SPR EA1N and EA2 PROJECTS

RESPONSE TO LETTERS FROM THE DEPARTMENT OF BUSINESS ENERGY AND INDUSTRIAL STRATEGY DATED 20 DECEMBER 2021

FLOOD RISK COMMENTS

Interested Party: SASSES **PINS Refs:** 20024106 & 20024110

OCOCP PLAN SHOWING

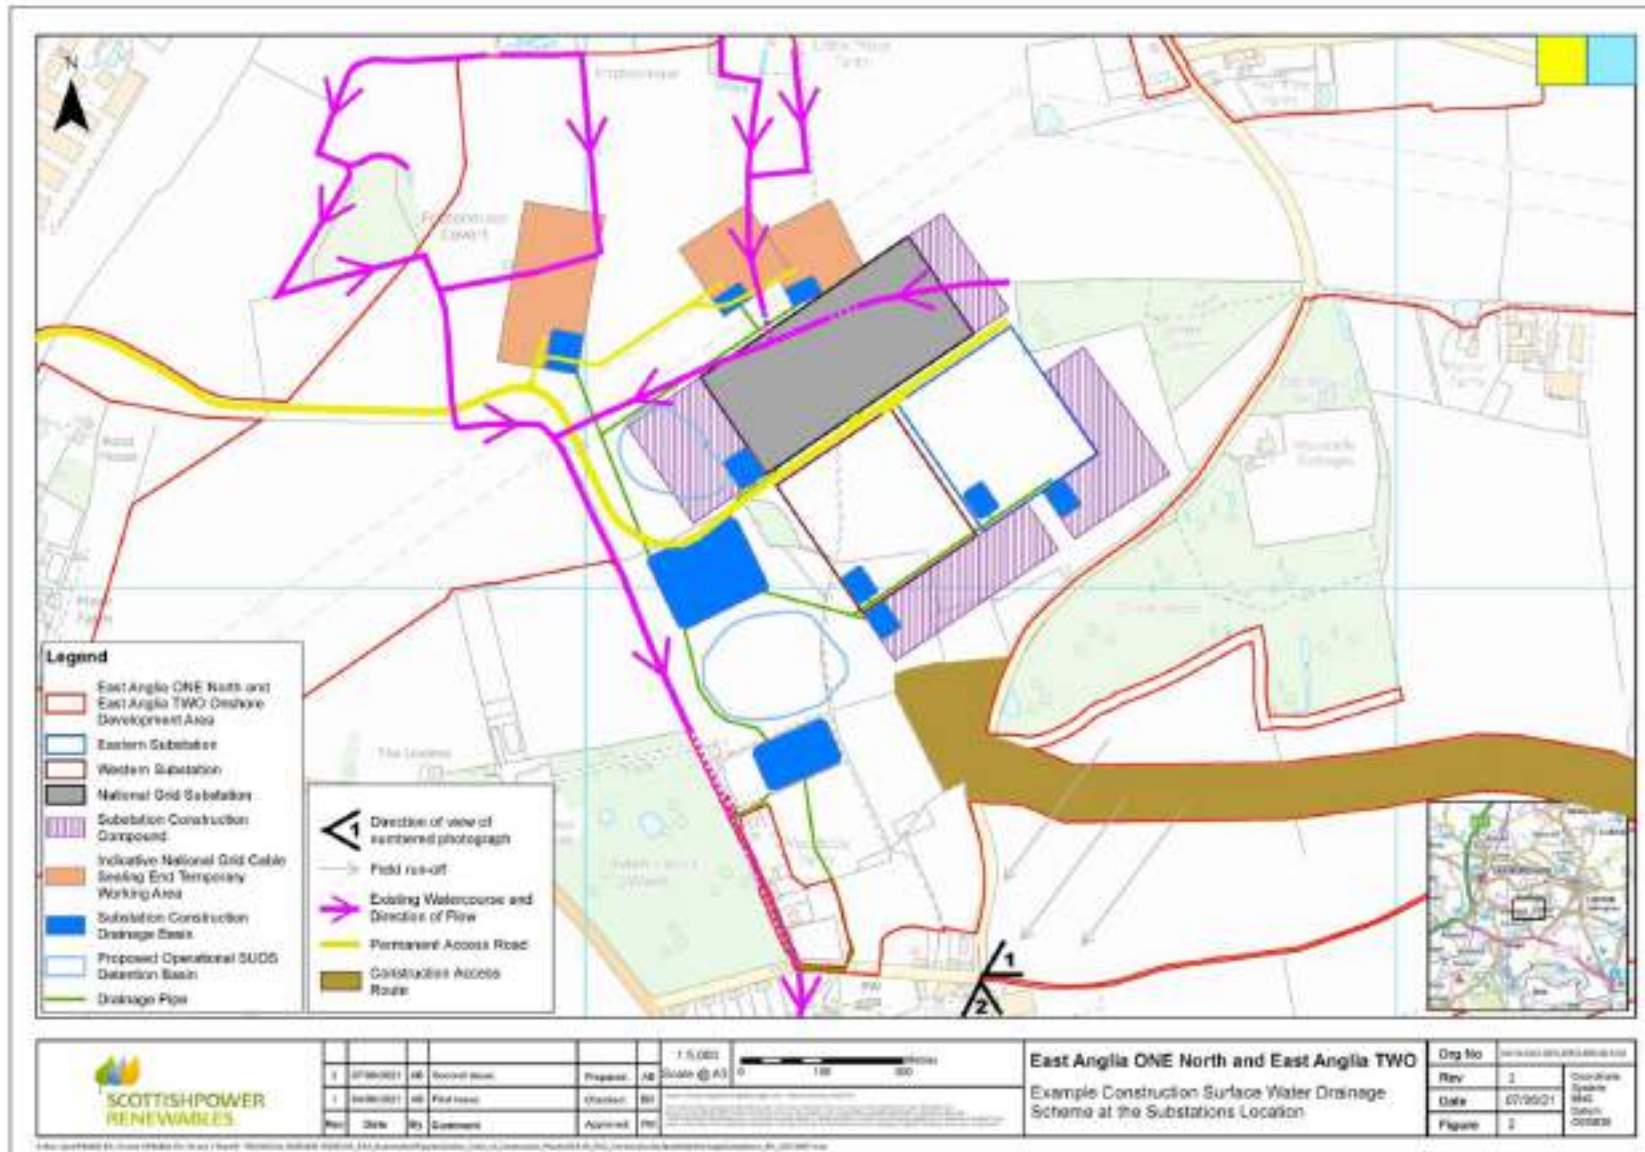
shown in the plan attached at Appendix 2. It should be noted the plan in the BMT Report is not complete as it omits this source of surface water flooding.

29. The very fact that there are no less than 10 separate construction drainage basins with very little detail of how they interact is telling, whilst also remaining unclear as to whether all parts of the disturbed ground will actually flow to these basins. Further the areas of impermeability and/or disturbance include the operational access roads to the substations and cable sealing ends which is not even reflected on the plan. The main operational access road also eliminates a natural drainage basin on the plan. This plan overlaid with the access roads is attached at Appendix 2.

WORKS PLAN FOR SUBSTATIONS CONSTRUCTION SITE SHOWING CABLE ROUTE AND HAUL/ACCESS ROAD (WORK NO.26)

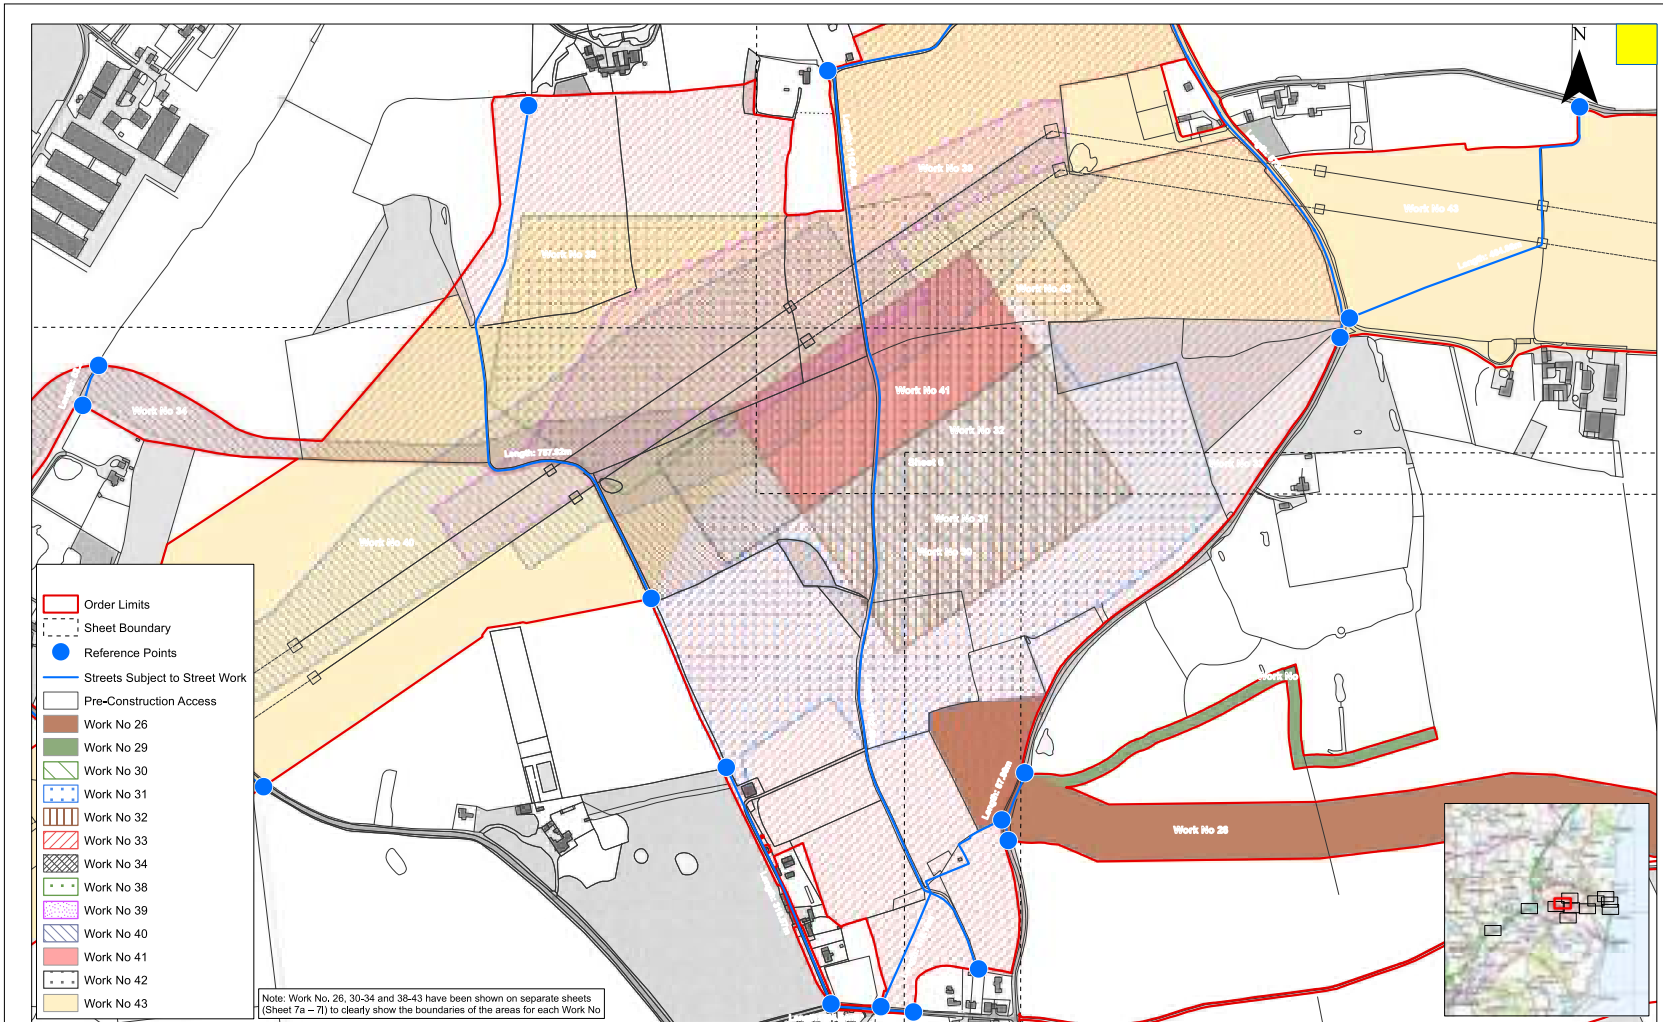
13. Another source is the agricultural land to the east of Grove Road which is of serious concern during the construction phase because this is the location of the cable route and haul/access road where it approaches, crosses and joins the substations construction site from the east to the west of Grove Road (Work No. 26) - see Works Plan attached at Appendix 4.

60. As well as works nos 30, 31, 34, 38, 41 and 42 the amendment should include references to the following works numbers:
- i. Work no. 26 cable route, haul road and construction access road approaching and at substation site,
